STAFF REPORT

SUBJECT: H-2022-0051; A-2022-0165
Klein Huis at Victory and Meridian –
AZ, CUP, PS

I. PROJECT DESCRIPTION

SHEET NUMBER: L150

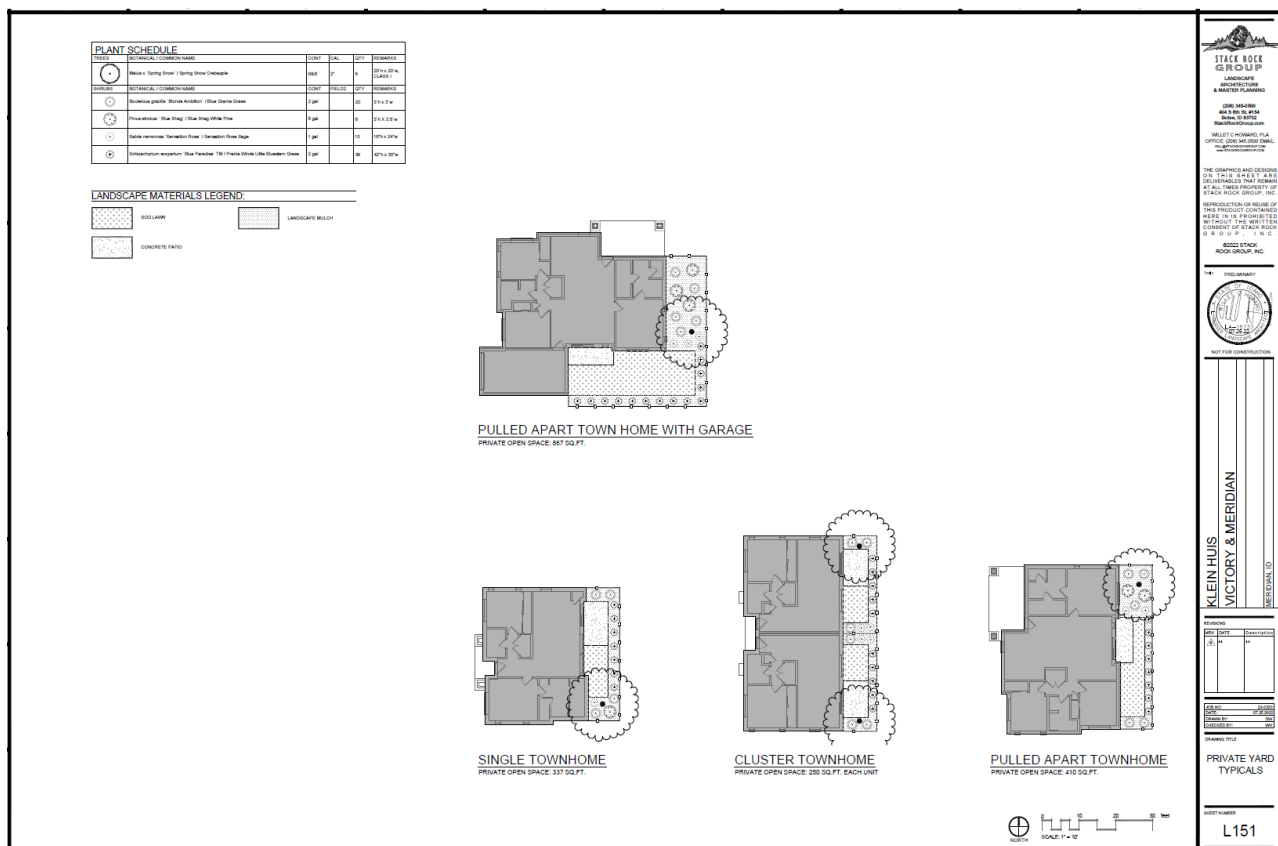
A 4-foot tall berm with a 6-foot tall vinyl fence on top of the berm is proposed as depicted on Sheet L150, which does not meet the construction standards for noise abatement. **The top of the wall is required to be a minimum of 10-feet higher than the elevation at the centerline of the state highway. The wall material is required to be impervious concrete or stucco or other appropriate sound attenuating material (vinyl does not qualify) and should comply with the standards listed in UDC 11-3H-4D.3.**

D. Open Space Exhibit

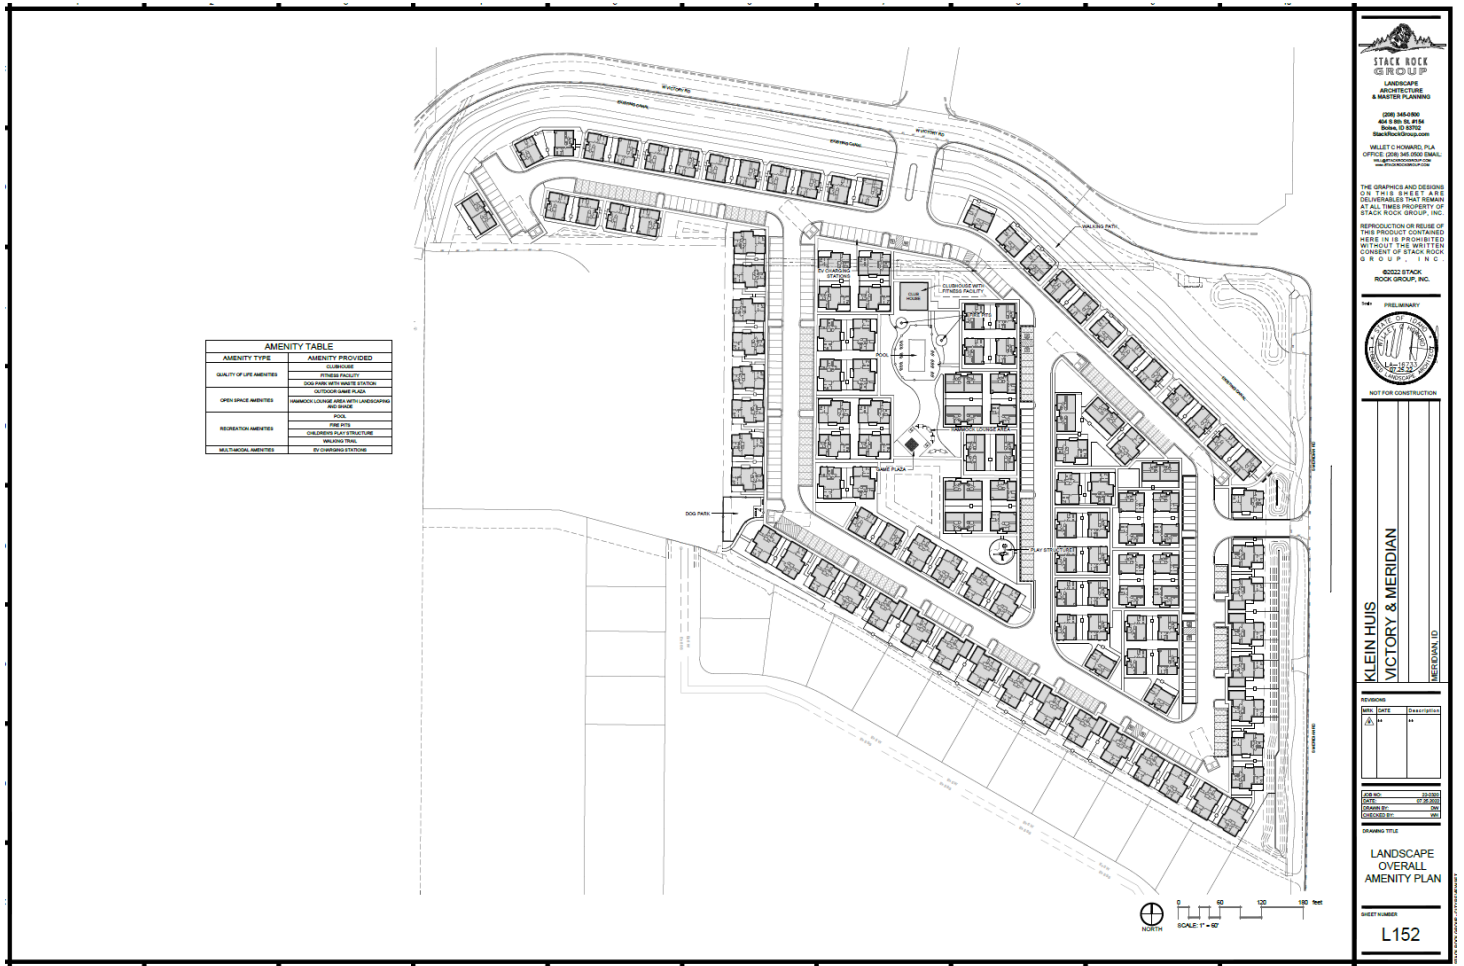
2. Common open space shall be not less than four hundred (400) square feet in area, and shall have a minimum length and width dimension of twenty feet (20'). ***The common open space areas proposed along the southern and western perimeter boundaries of the site are less than 20' in width and do not meet this requirement. Some of these areas also include private open space areas.***

Staff is unable to determine if the minimum standards are met based on the submitted common open space exhibit, which includes many areas that don't qualify; revisions are needed to the plan in order to determine compliance with the minimum standards.

G. Connectivity Exhibit

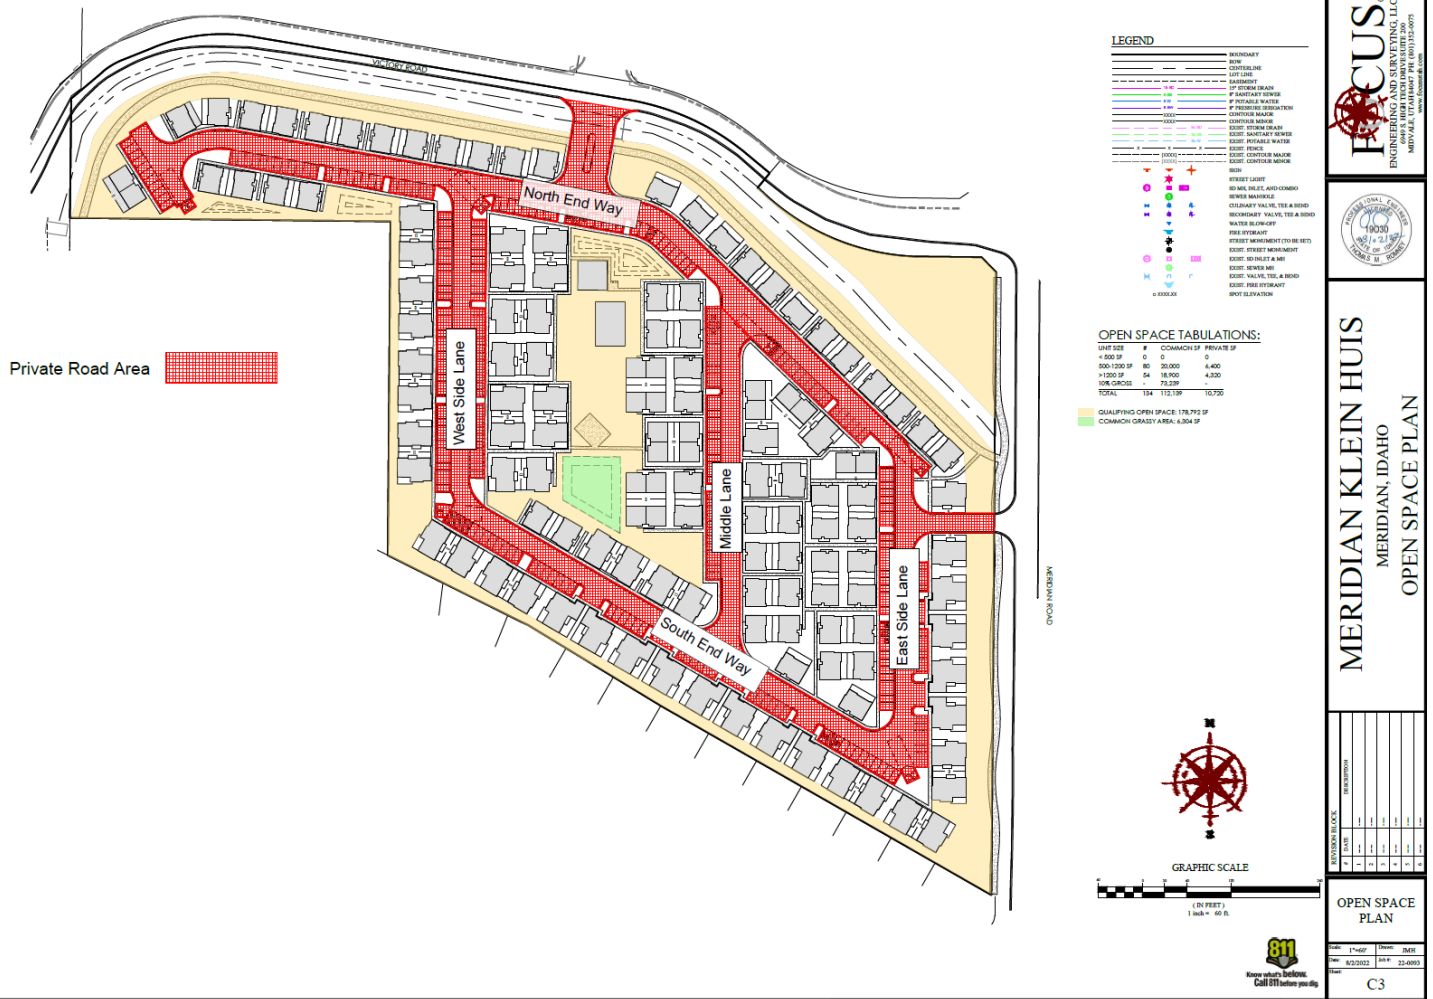
A connectivity exhibit was submitted by the Applicant, included in Section IX.G, that depicts the extension of existing stub streets from the west (W. Contender Dr.) and south (S. Peoria Way) through the Brewer-Schmidt out-parcel at the southwest corner of this site – no connectivity is proposed with this site, which is not consistent with the goals in the Comprehensive Plan pertaining to connectivity between neighborhoods.
